INDESIT company

Model type:
WA8XIT

Commercial code:
F026882

Notices

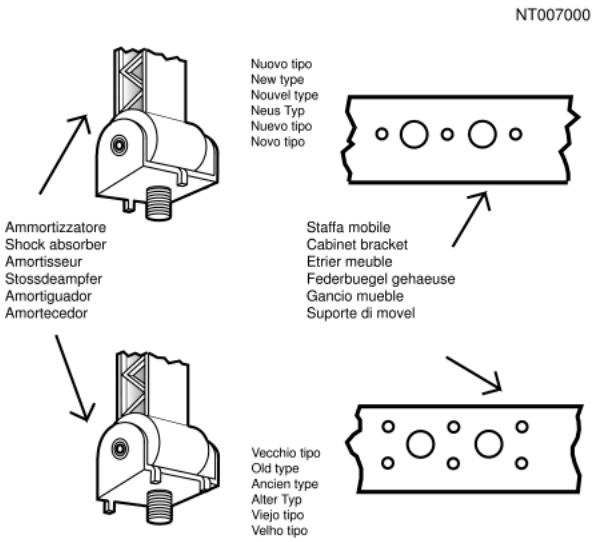
n1040246: Button switch NO

From serial number 20302.0001, the button switch NO code 088394 is used instead of the premodified switch NO+NO code 075445 (see attached illustration) and the button switch SE-NO code 063971 is used instead of the premodified switch SE-NO code 058465 (see attached illustration) on washing machine AL68XPT .
Both switches are regularly managed, therefore in case of repair the serial number of the unit must be taken into consideration.
This modification also regards the wiring code 088448 which as with all the LB 2000 models, is managed only by request, i.e. without stock, in order to always manage the interchangeable one with the last modification.
Due to the simplicity of the modification, the images of the wiring diagrams used remain the same as the IDC wiring diagrams already available on the WEB.
The modification will be also extended to other models which from time to time will be listed below.

n1040282: New drainage OKO system.

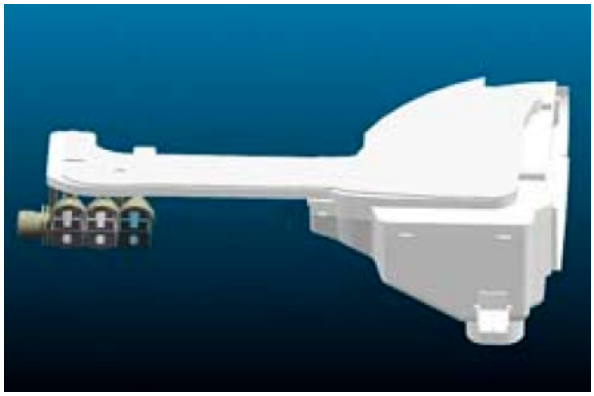
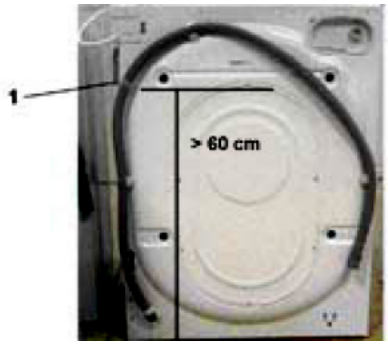
From serial number 21219.0001, the new "OKO" drainage system has been introduced on the washing machines produced in the Comunanza factory.
The last two numbers of the Industrial Code (located on the rating plate) of the models relevant to this note will be 30 (e.g. 80233560130 - see Appendix A)

The new items are:

- EEPROM (the OKO system requires a new setting of load timing parameters). THE NEW EEPROMS REPLACE ALL THE ONES CODED PREVIOUSLY.
- BOWL (hopper tube hole shifted forwards);
- DETERGENT LOADING TUBE (see fig. 1);
- PRESSURE SWITCH (changed levels);
- OKO PUMP BOWL BLOWER + BALL (see fig. 2A, 2B and 2C);
- CONDUCTIVITY SENSOR (if provided, it is shorter than the premodification item);
- DRAIN PUMP (without detergent collecting tube connection);
- HOPPER (shifted in front of detergent loading tube connection). Fig. 3A post-modification. Fig. 3B premodification);
- AIR TRAP (different shape);
- PRESSURE SWITCH TUBE (different length);
- DRAIN TUBE STOP (specific);

In particular, the OKO system consists of a spherical plastic component inserted in the tube that connects the bowl to the drain pump (see fig.2 A).
At the beginning of each wash cycle the washing machine fills water for 10 seconds and activates the drain pump for 2 seconds. In this way, the water level in the bowl is different from that in the drain tube; this difference increases the thrust of the ball upwards, closing the bowl-pump connection tube hermetically (see fig. 2D).
This system has the double advantage of:

1) separating the wash water and the water in the drain hose, thus saving energy during the heating phase;
2) and ensuring optimal use of all the detergent.
With the introduction of this new component, the detergent collecting tube is no longer required and the pump has one hole only to convey water from the tank.
For the correct operation of the OKO system, it is important that the drain hose of the washing machine remains fixed to the back of the unit with a plastic clamp (to this end, the clamp withstands a 25 kg load; see reference 1 in fig. 4); otherwise, the drain hose must absolutely reach the height of the clamp. (minimum 60 cm.)

n1040325: New shock absorber fixing system with pin

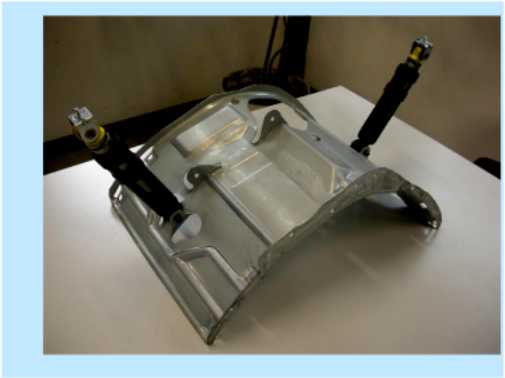
From serial no. 40427.0001, shock absorbers have been fixed to the tank unit cradle with two 11 mm pins code C00110163 (see fig. 01 and 02 enclosed) in place of the 8 mm screws code 093750 and relevant locking nuts code 030443, on all washing machines and dryers produced in the Comunanza factory.
The items affected by this modification are:
1) The cradles have the same Service code, as they can be used in place of the new ones after widening the shock absorber fixing holes to a diameter of 10 mm.

Code 093848 - Tank unit cradle 46 lt
Code 093878 - Tank unit cradle 40 lt.
2) The new shock absorbers, with fixing bushing having no s/steel spacer, are not managed as they are interchangeable with the premodified items (make sure they are CIMA type, as the managed items), fixed with M8 screws code 093750 and related locking nut code 030443 (see figs. 05 and 06).
Code 093884 - Shock absorber 80 N
Code 093885 - Shock absorber 100 N

To remove the shock absorber from the tank, first extract the pin with a few hammer taps (see fig.03) until it is aligned with the tank bracket and then pull it out with a pair of pliers (see fig. 04).
(To refit the shock absorber use a new pin. Insert the pin until the toroidal edge is aligned with the bracket.)
